Arlington Zoning Board of Appeals

2. #3747 10 Sunnyside Avenue

Reference Material	2023-06-13_10_Sunnyside_ZBA_Hearing_3_Presentation.pdf	ZBA Hearing 3 Presentation
Reference Material	Henderson_Letter_10_Sunnyside.pdf	Henderson_Letter 10 Sunnyside
Reference Material	2023-06-09_10_Sunnyside_Arlington_Civil_Set_Plan_Updates_-_Revised.pdf	2023-06-09_10 Sunnyside Arlington Civil Set Plan Updates - Revised
Reference Material	2023-06-13_10_Sunnyside_ZBA_Hearing_3_Presentation_-_Revised.pdf	2023-06-13_10 Sunnyside ZBA Hearing 3 Presentation - Revised
Reference Material	TertraTech_letter_to_Christian_Klein_-_Comprehensive_Permit_10_Sunnyside.pdf	TertraTech letter to Christian Klein -Comprehensive Permit 10 Sunnyside
Reference Material	10_Sunnyside_Revised_List_of_Requested_Waivers_7-2023.pdf	10 Sunnyside Revised List of Requested Waivers 7-2023
Reference Material	10_Sunnyside_-_Comprehensive_Permit_Peer_Review_Response_-_July_31_2023.pdf	10 Sunnyside - Comprehensive Permit Peer Review Response - July 31 2023

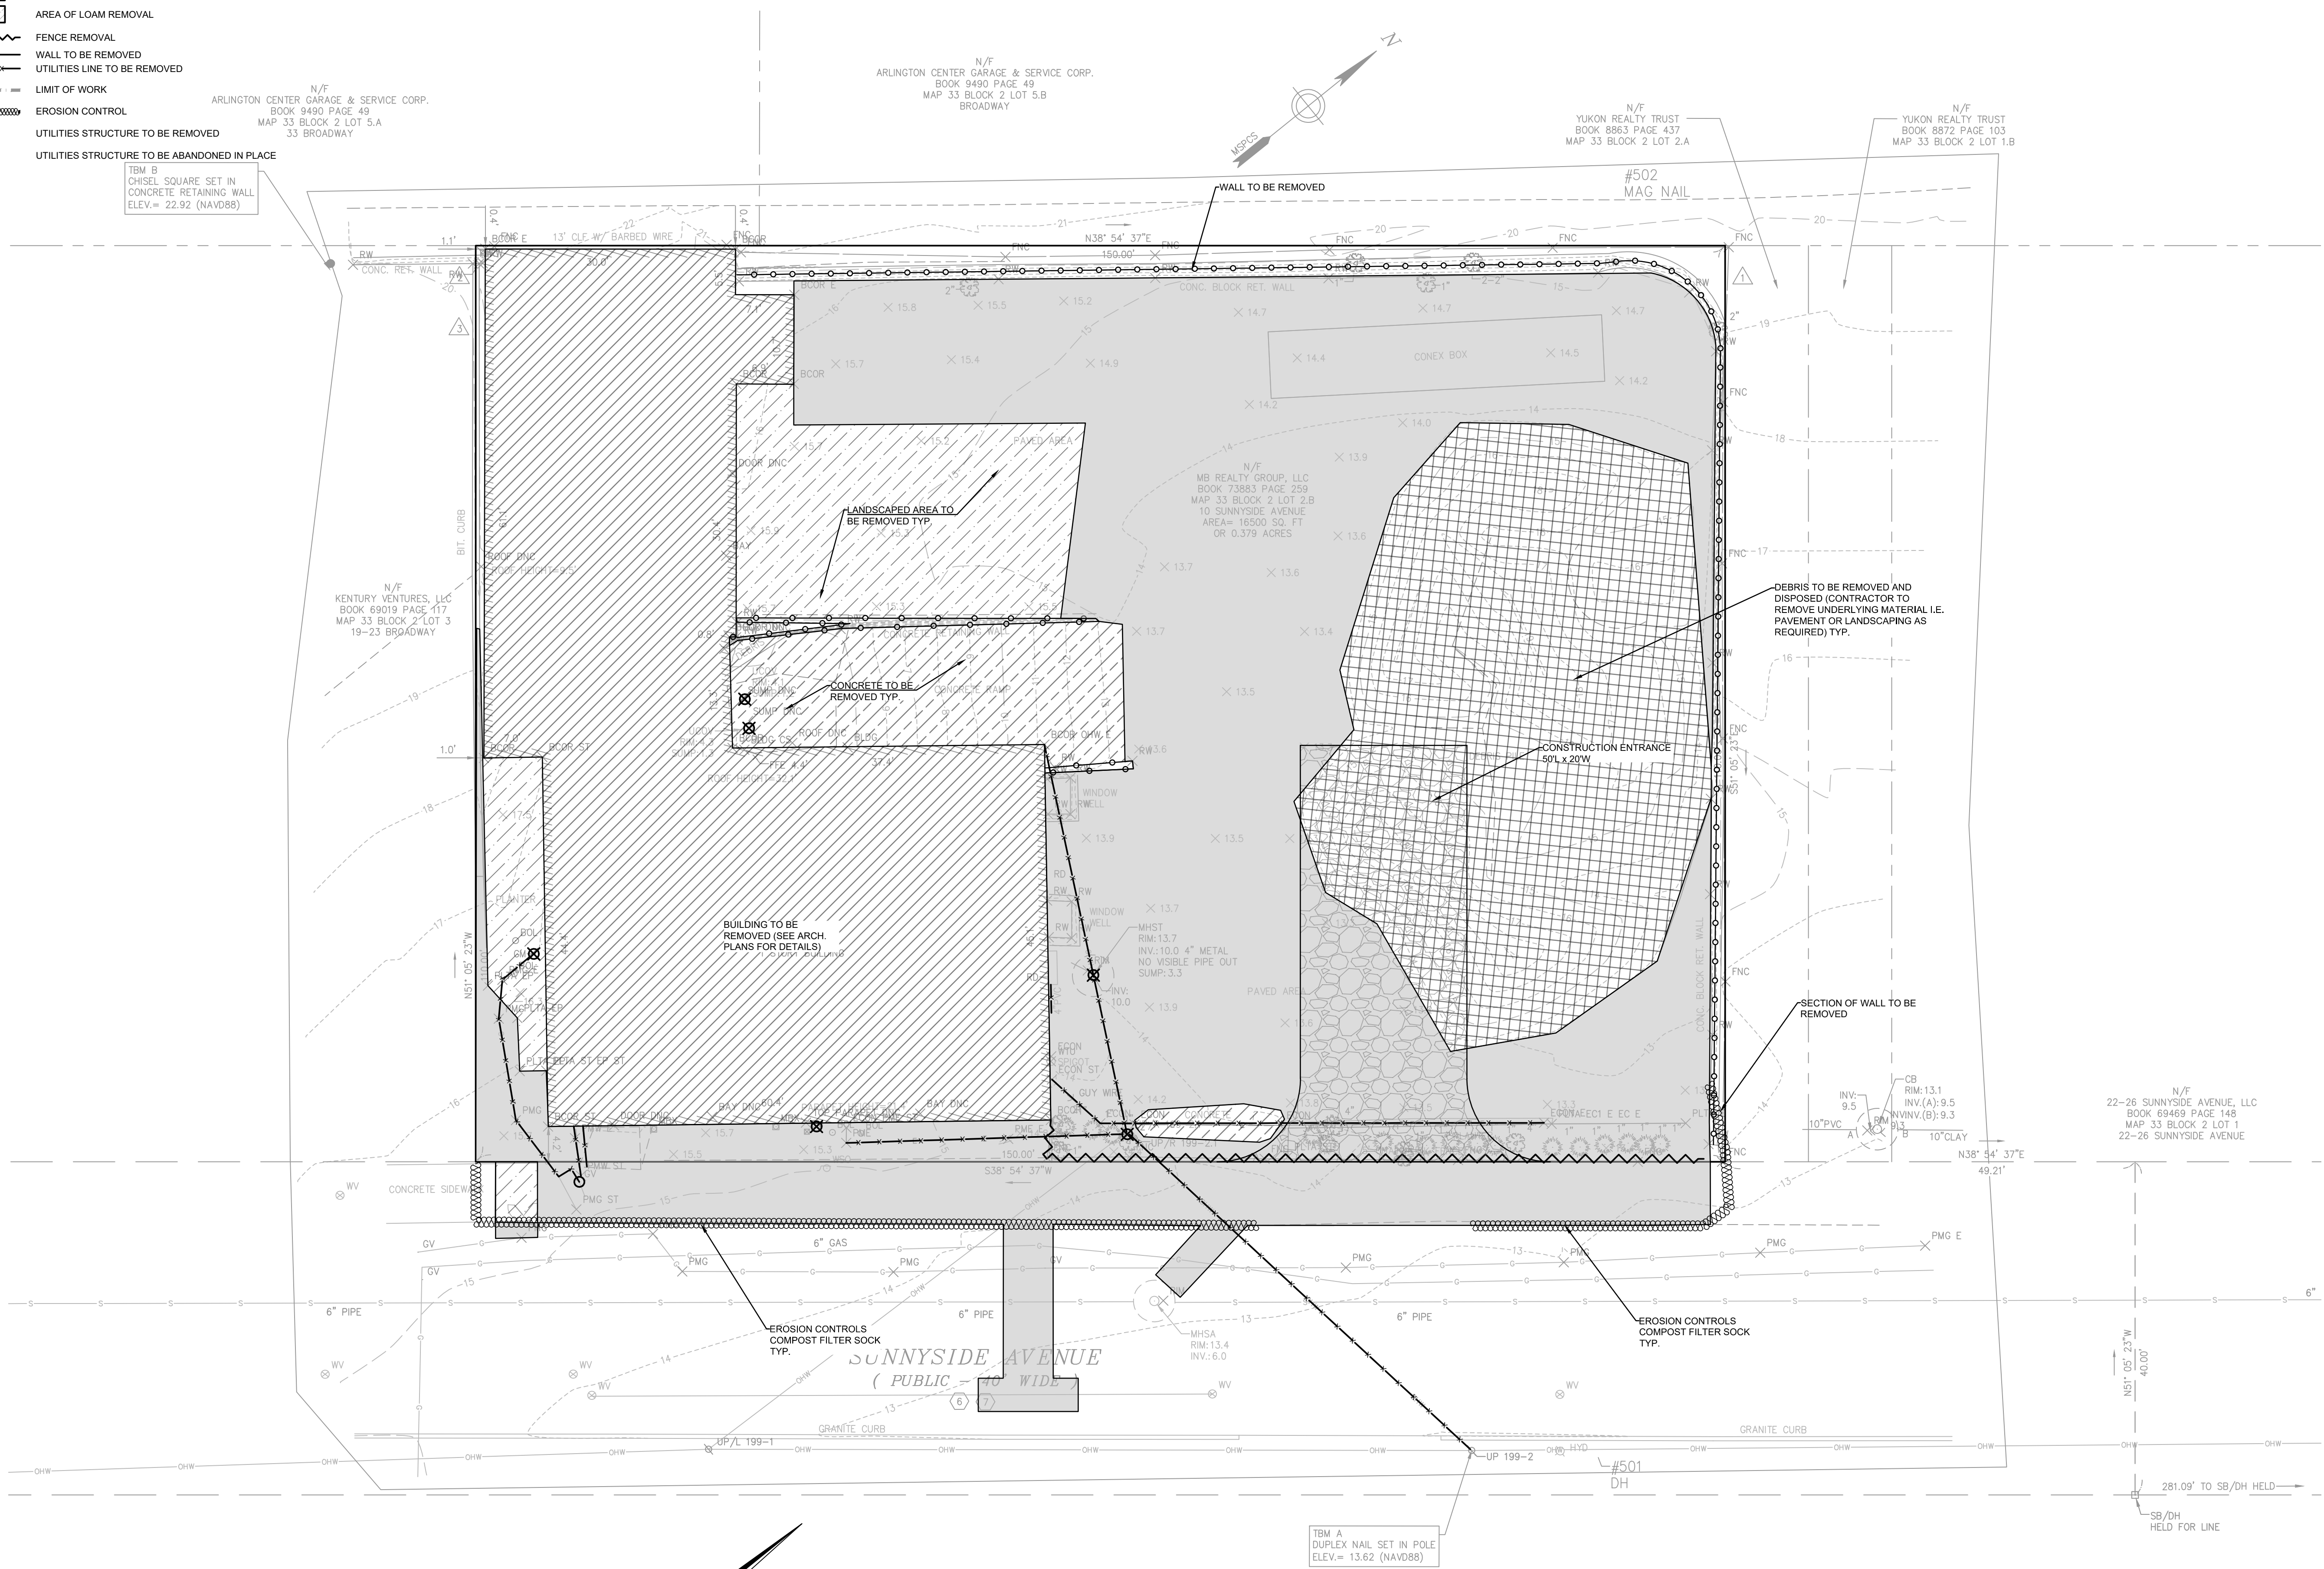
- Will PV panels be flat or raised ?

Response: PV panels will be ballasted roof-mount system approximately 18" tall; they will not be visible from the street.
